CONSISTENCY MEETING

Date: 9/10/2014

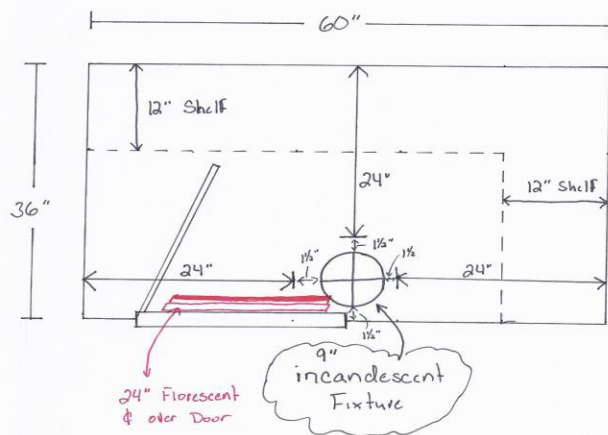
This section doesn't mention the front wall. We are having issues with Inspectors defining "Closet storage space". 410.16 (C) (1) States the minimum clearance for an incandescent fixture installed on the wall above the door or on the ceiling. I have been told by several inspectors that Gerald Barnes has a picture of a closet where a homeowner installed a shelf above the door after the Homeowner moved in. In result of this picture, our inspections have been failing due to light clearance off the front wall. Please see attached picture.

I've been told that a 24" florescent style fixture mounted on wall, centered over top of door, (per the attached drawing) is also unacceptable. (Gerald B)
